# DART SERVICE INSTRUCTION

TO AMEND INSTALLATION INSTRUCTIONS IIN-D135-1027 REV. E AND  
INSTRUCTIONS FOR CONTINUED AIRWORTHINESS ICA-D135-1027 REV. 2 OR LATER APPROVED REVISIONS  
REF. TCCA STC: SH18-49  
REF. FAA STC: SR04276NY  
REF. EASA STC: 10068097  
REF. DGAC MEXICO STC: IA-633/2019

DRAWING NO.  
**DSI 9853**

TITLE  
**STEP COMPATIBILITY**

**FIGURE 1**  
EC 135 LANDING GEAR

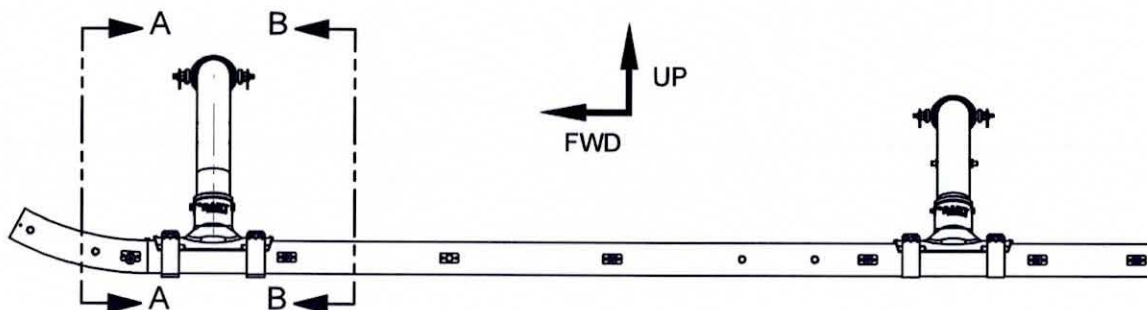
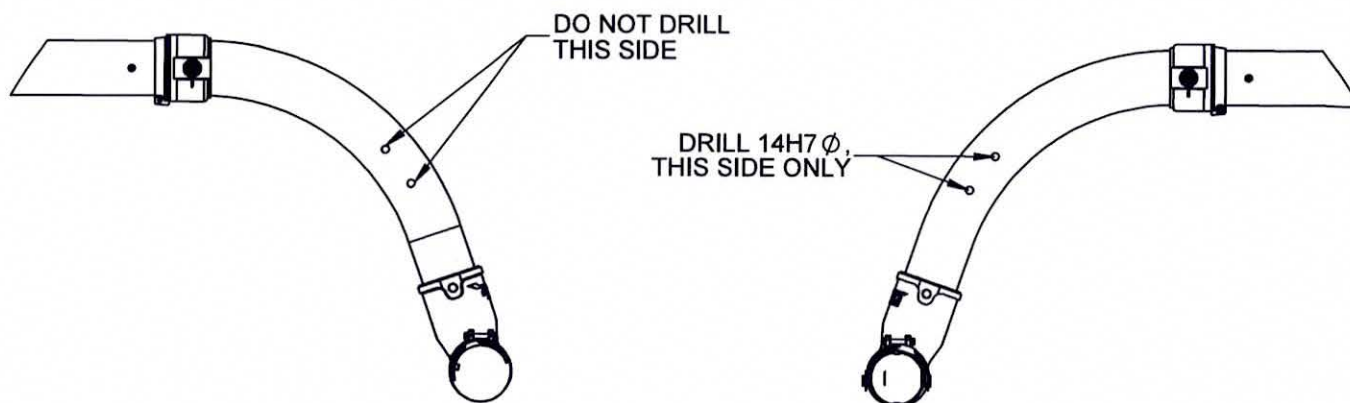
- 2.1 If present, remove standard entrance step and attachment hardware from landing gear in accordance with Airbus Helicopters SB EC135-32-013.
- 2.2 Drill 14H7  $\phi$  (range of tolerance 14.0 mm to 14.018 mm) on the aft side of forward crosstube only. Leave the holes in the forward side of the forward crosstube at  $\phi$  12mm. Refer to Figure 1 of this DSI.

- 2.3 Deburr all drilled holes and remove any debris from the inside of the crosstube. Touch up affected area per section 5.3.10 of ICA-D135-1027.
- 2.4 If retrofitting Airbus Helicopters standard steps, install step bracket attachment fitting in accordance with Airbus Helicopters SB EC135-32-013. Otherwise, install the Airbus Helicopters steps in accordance with the Aircraft Maintenance Manual.
